**METROPOLITAN GOVERNMENT OF NASHVILLE AND DAVIDSON COUNTY**

**STAFF RECOMMENDATION**  
**2114 19<sup>th</sup> Avenue South**  
**June 20, 2012**

**Application:** New construction-accessory and Setback reduction  
**District:** Belmont-Hillsboro Neighborhood Conservation Zoning Overlay  
**Council District:** 18  
**Map and Parcel Number:** 10416002500  
**Applicant:** Michael Ward, Allard Ward Architects  
**Project Lead:** Robin Zeigler, robin.zeigler@nashville.com

<p><b>Description of Project:</b> Applicant proposes to construct a one- and one-half story accessory building.</p> <p><b>Recommendation Summary:</b> Staff recommends approval of the accessory structure at 2114 19<sup>th</sup> Avenue South with the condition that staff review final specifications of windows and doors and the metal roof and that the garage have two separate doors rather than one eighteen foot wide opening. With these conditions met, the project meets the design guidelines for accessory buildings in the Belmont-Hillsboro Neighborhood Conservation Zoning Overlay.</p>	<p><b>Attachments</b>  <b>A:</b> Photographs  <b>B:</b> Site Plan  <b>C:</b> Elevations</p>
---	---

Rear yard.

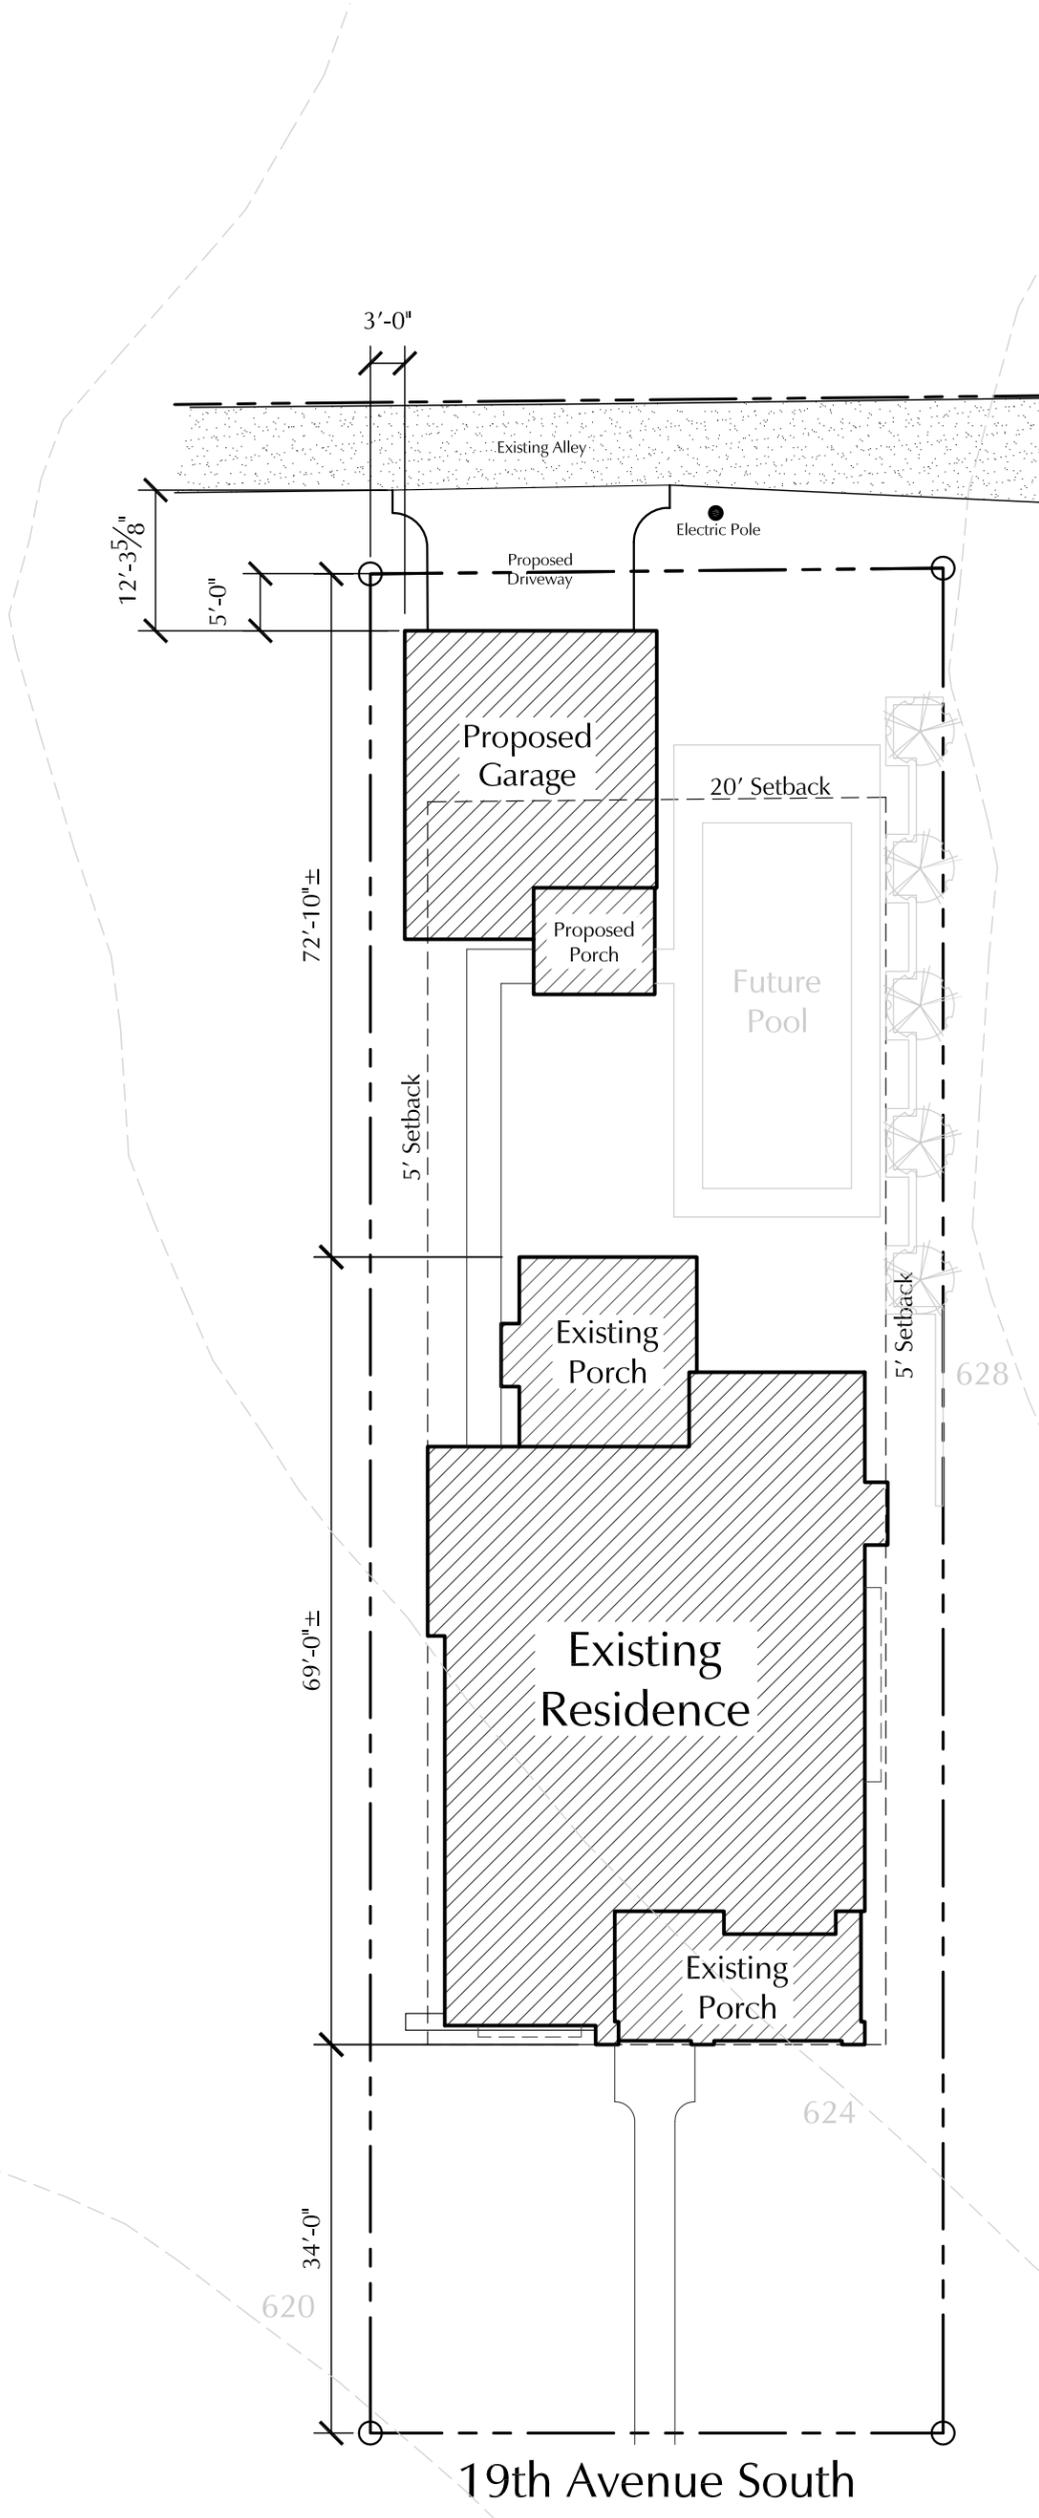
**Location:** The garage is located towards the rear of the lot with access from the alley. The accessory building is proposed to be five feet (5') from the rear property line; however, code requires ten feet (10') when the doors face the alley. Historic accessory structures were often located close to or even on the property line. Staff finds the proposed location to be appropriate and recommends approval of the setback reduction.

1 Garage Plan  
Scale: 1/8"=1'-0"

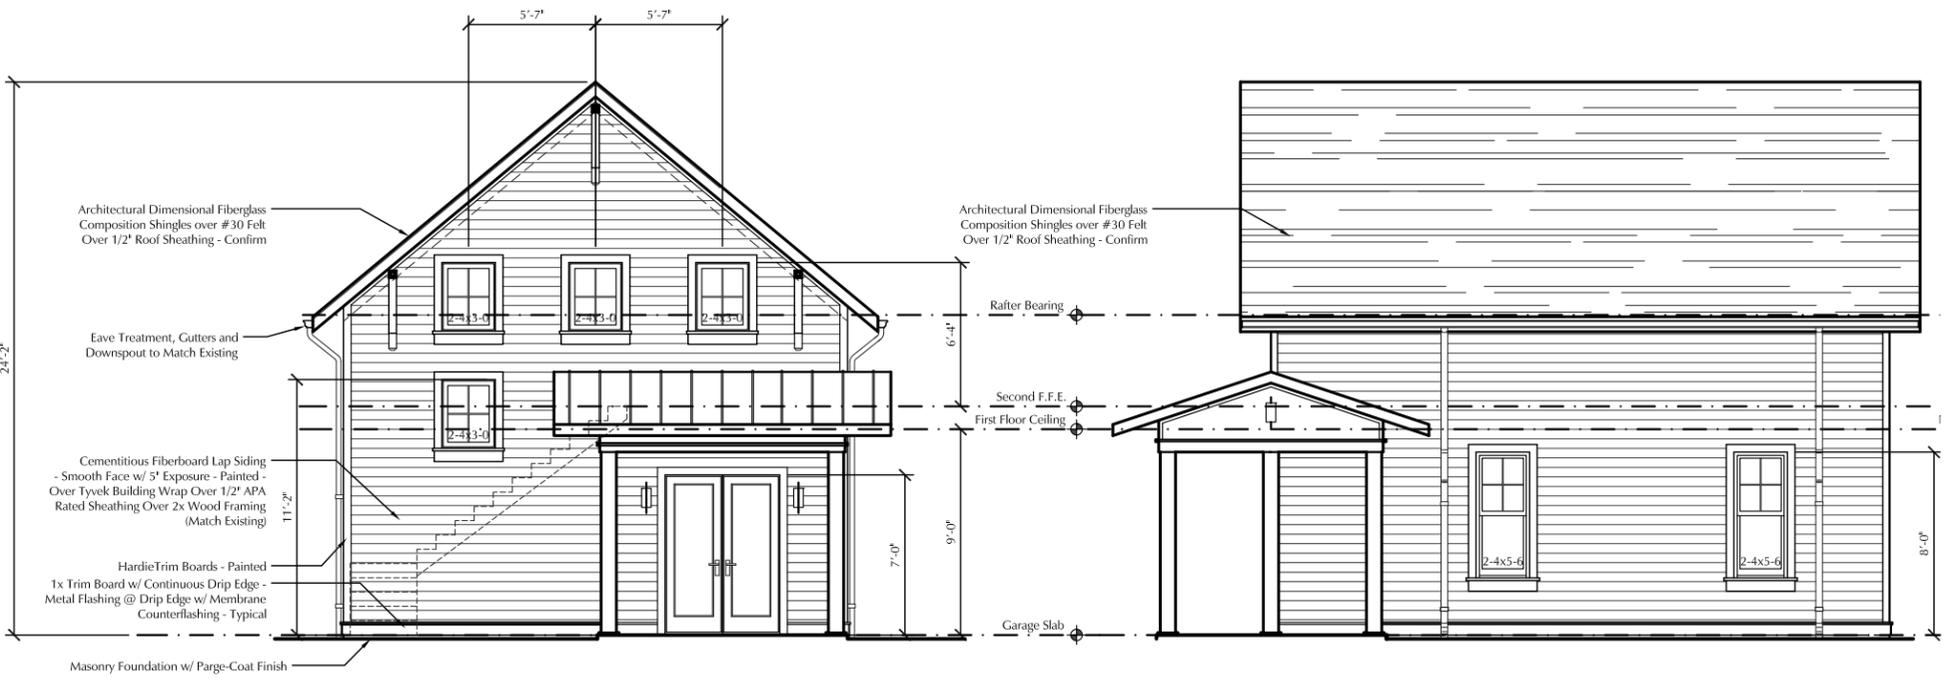
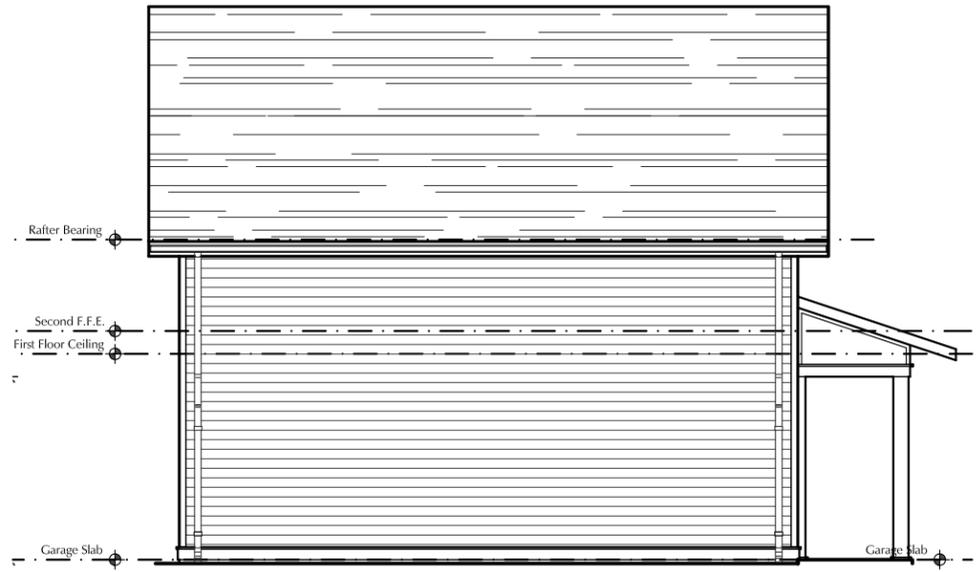
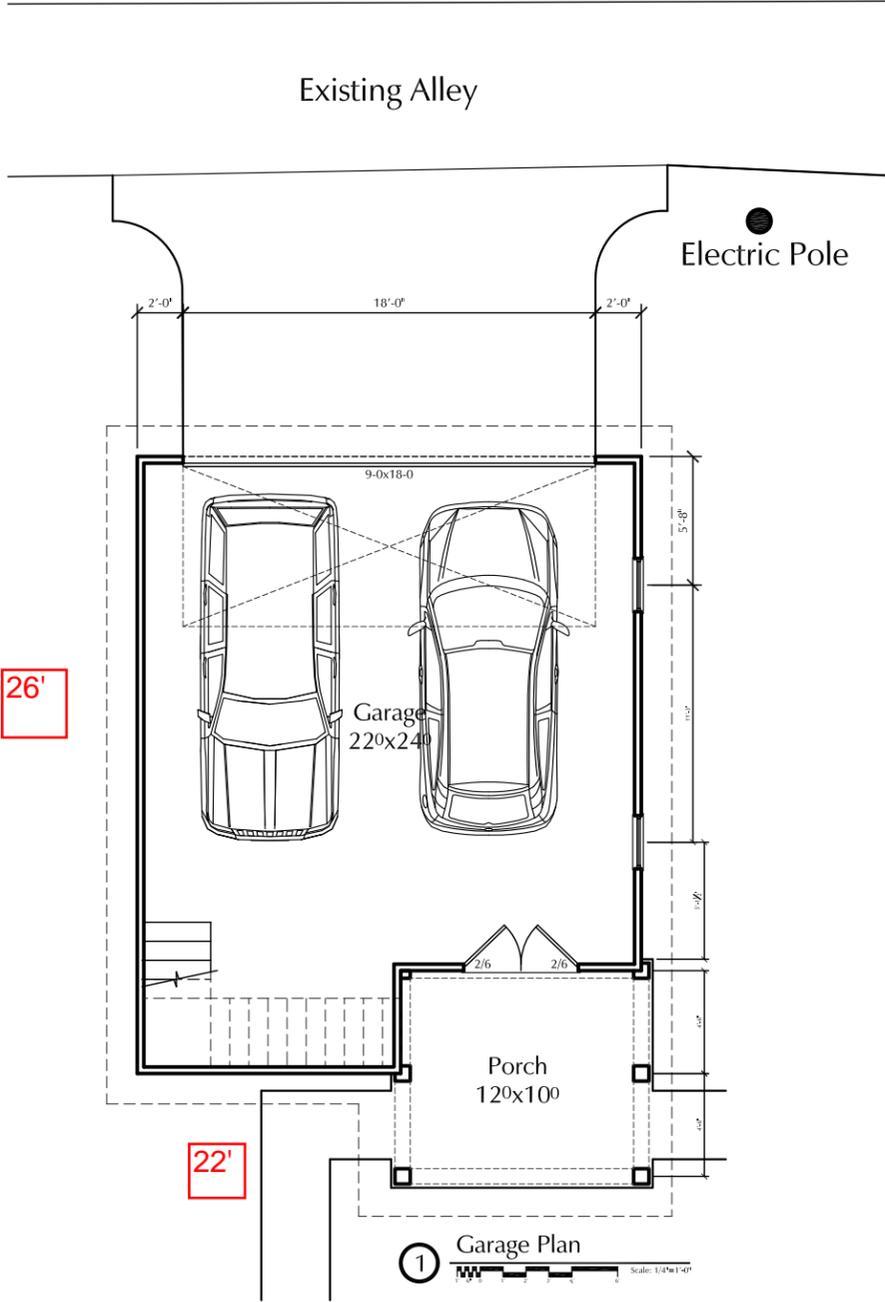
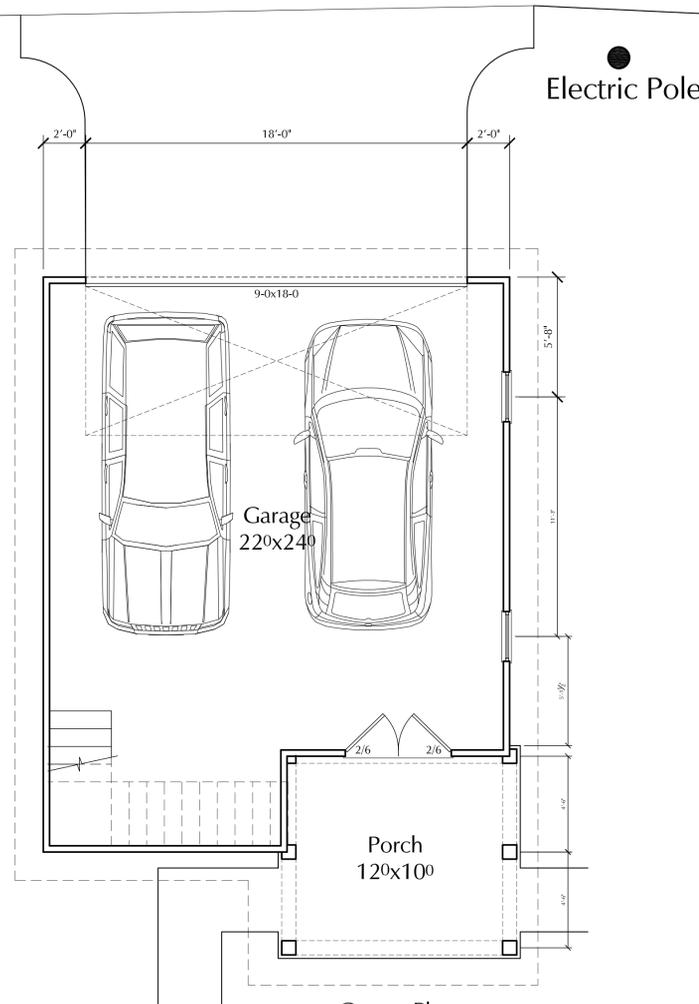
Staff recommends approval of the accessory structure at 2114 19<sup>th</sup> Avenue South with the condition that staff review final specifications of windows and doors and the metal roof and that the garage have two separate doors rather than one eighteen foot wide opening.

2 North Elevation  
Scale: 1/4"=1'-0"

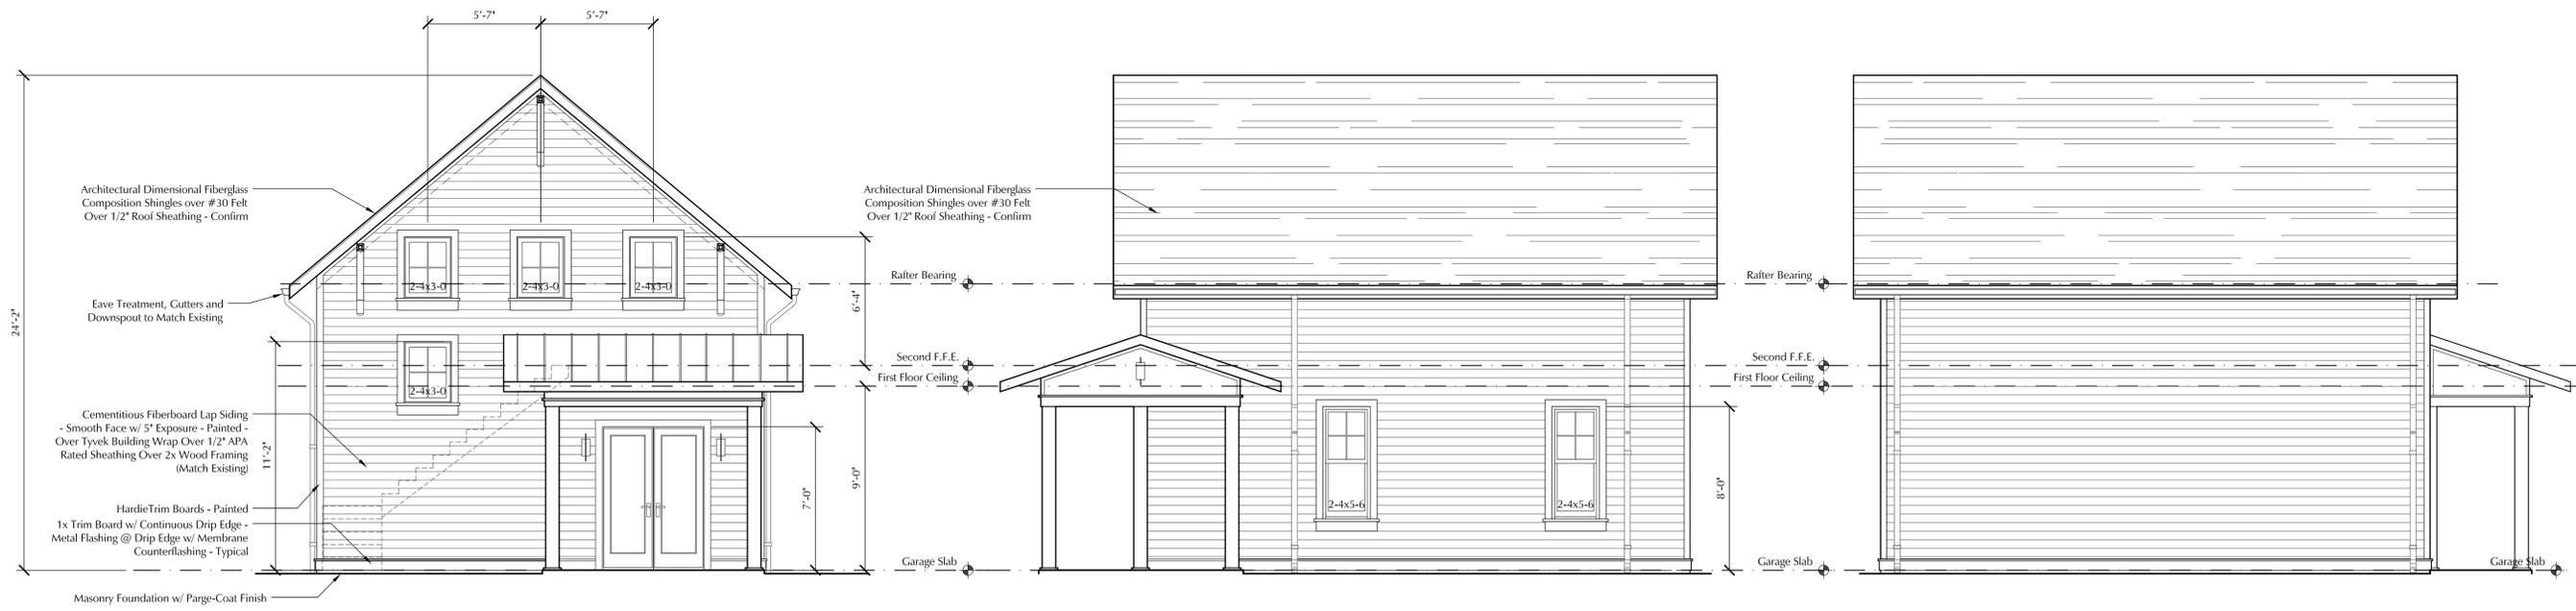
**Height & Roof:** The height of the garage is proposed to be 24' and 2" from grade. The primary house is 33' tall. Being approximately nine feet (9') shorter than the primary building, the accessory building reads as subordinate. The roof pitch, form and overhang is similar to the existing building.

**Windows and Doors:** The street facing side has a porch with double doors and four windows while the vehicular door is on the alley side; however, the building will be minimally visible from the public right-of-way.

**Materials:** The materials of the garage match the existing house. The drawings call out the siding as cement fiber lap siding with a five inch (5") reveal; however, it will be wood with an alternating five inch and two inch (5" and 2") reveal and mitered corners. The roofing material will be asphalt shingle and metal. The vehicular door will be paneled aluminum. The material of the pedestrian door and the color of the roof is unknown. The windows will be wood. Staff recommends final review of windows and doors and the color of the metal roof.
